Remarks/Arguments

Application No. 09/848,112 Amt. dated Feb. 5, 2004 Reply to Office action of Aug. 11, 2003

FIG.**2** 3

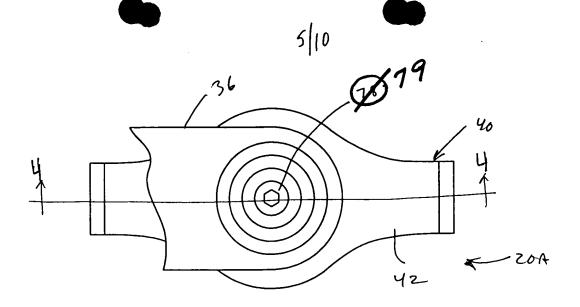
The drawings are objected to because Figures 3, 4A and 4B appear incorrect. Particularly, it is indicated that reference "78" of Fig. 3, "90" of Fig. 4A, "86" and "96" appear questionable. Formal drawings are submitted herewith. Reference "78" of Fig. 3 has been changed to reference "79." Reference "90" of Fig. 3 has been removed. References "86" and "96" are correct as originally submitted. Reference "86" refers correctly to the cylindrical wall of the pivot ball. See Present Application, pg. 7, line 16. Reference "96" refers correctly to the aperture formed in the pivot ball. See Present Application, pg. 7, line 31.
